# Test and Balance Punch List - Mar 25, 2024

**L05068\_Spring Station FSU (KY)**

962 Breckenridge Lane, Louisville, Kentucky

**#593 Grease Cleanout Doors Sized Incorrectly.**

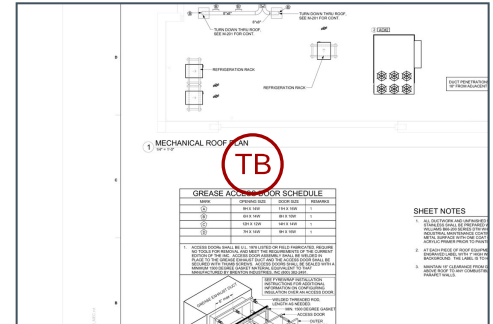
Cleanout doors do not meet size specifications listed in cleanout door schedule on M-250.

## #563 RTU SENSOR LABELS: Improper Label

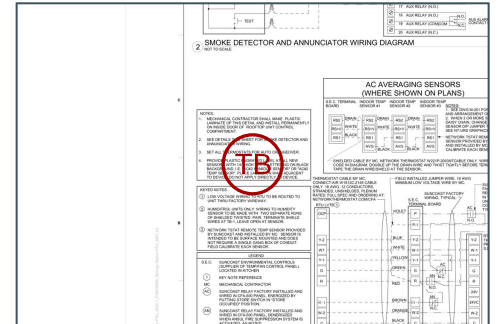
See M-501, Detail 1, Note 4:  
1/4" High white  
Lettering on black  
background. Label on wall  
ADJACENT TO DEVICE.  
Sensors improperly  
Labeled.
